KEWAUNEE POWER STATION IMPROVED TECHNICAL SPECIFICATIONS CONVERSION

ITS CHAPTER 1.0 USE AND APPLICATION

Revision 0

Current Technical Specification (CTS) Markup and Discussion of Changes (DOCs)

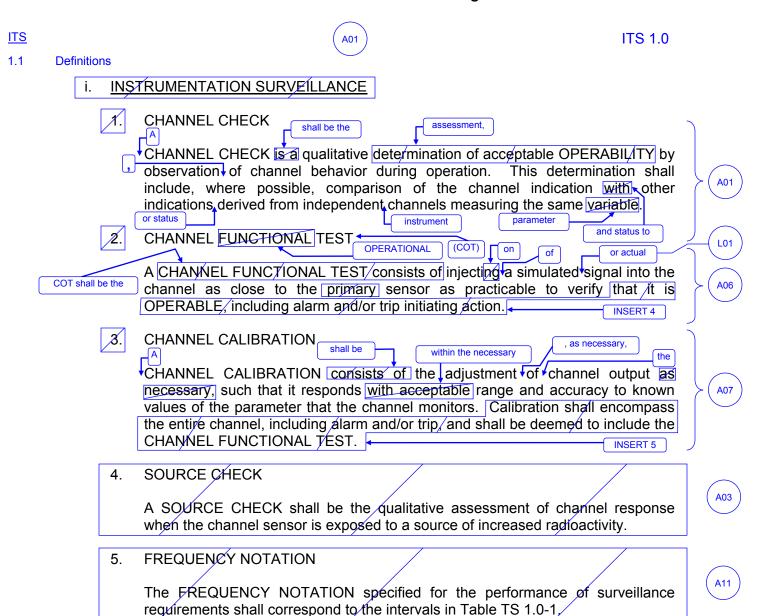
(A03

DEGREE OF REDUNDANCY is defined as the difference between the number of OPERATING channels and the minimum number of channels which, when tripped, will cause an automatic shutdown.

A03 CTS Section 1.0 includes the following definitions:

The ITS does not use this terminology and the ITS Section 1.1 does not contain these terms in the ITS.

These changes are acceptable because the terms are not used as defined terms in the ITS. Discussions of any technical changes related to the deletion of these terms are included in the DOCs for the CTS sections in which the terms are

INSERT 5

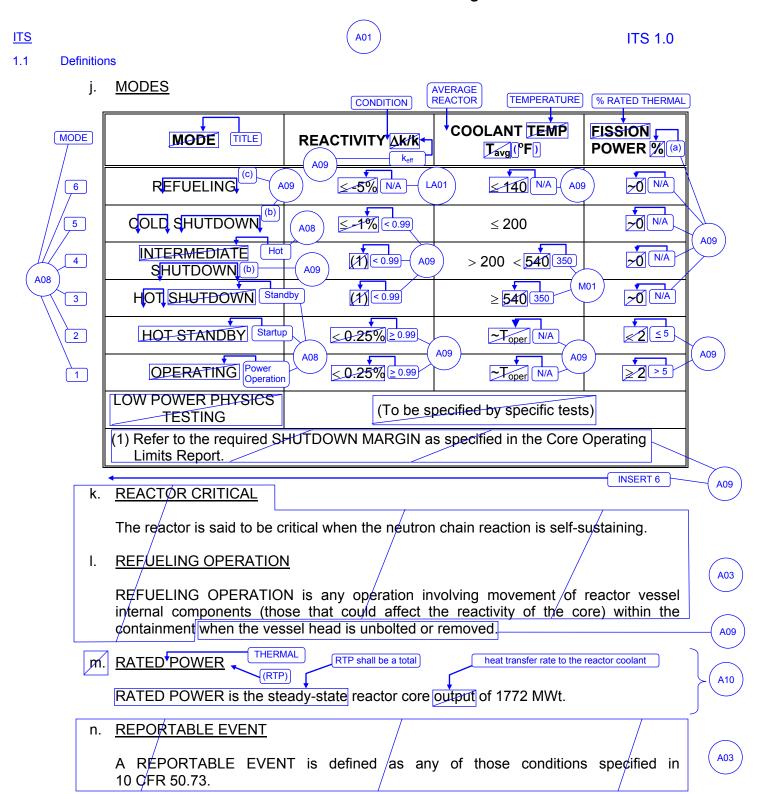
The CHANNEL CALIBRATION shall encompass all devices in the channel required for channel OPERABILITY. Calibration of instrument channels with resistance temperature detector (RTD) or thermocouple sensors may consist of an inplace qualitative assessment of sensor behavior and normal calibration of the remaining adjustable devices in the channel. The CHANNEL CALIBRATION may be performed by means of any series of sequential, overlapping, or total channel steps.

encompass the entire channel, including alarm and/or trip, and shall be deemed to include the CHANNEL FUNCTIONAL TEST." ITS defines a CHANNEL CALIBRATION as "the adjustment, as necessary, of the channel output such that it responds within the necessary range and accuracy to known values of the parameter that the channel monitors. The CHANNEL CALIBRATION shall encompass all devices in the channel required for channel OPERABILITY. Calibration of instrument channels with resistance temperature detector (RTD) thermocouple sensors may consist of an inplace qualitative assessment of sensor behavior and normal calibration of the remaining adjustable devices in the channel. The CHANNEL CALIBRATION may be performed by means of any series of sequential, overlapping, or total channel steps." This results in a number of changes to the CTS.

The CTS definition states, "calibration shall encompass the entire channel, including alarm and/or trip." The ITS states, "The CHANNEL CALIBRATION shall encompass all devices in the channel required for channel OPERABILITY."

This change is acceptable because the statements are equivalent in that both require that all needed portions of the channel be tested. The ITS definition reflects the CTS understanding that the CHANNEL CALIBRATION includes only those portions of the channel needed to perform the safety function.

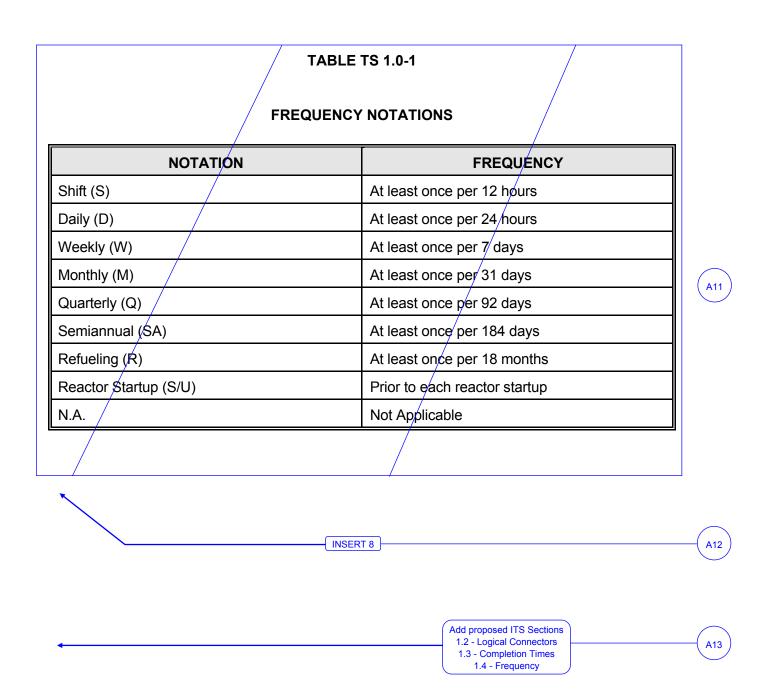
LEAKAGE shall be:

a. Identified LEAKAGE

- LEAKAGE, such as that from pump seals or valve packing (except reactor coolant pump (RCP) seal water injection or leakoff), that is captured and conducted to collection systems or a sump or collecting tank
- LEAKAGE into the containment atmosphere from sources that are both specifically located and known either not to interfere with the operation of leakage detection systems or not to be pressure boundary LEAKAGE, or
- 3. Reactor Coolant System (RCS) LEAKAGE through a steam generator to the Secondary System (primary to secondary LEAKAGE);
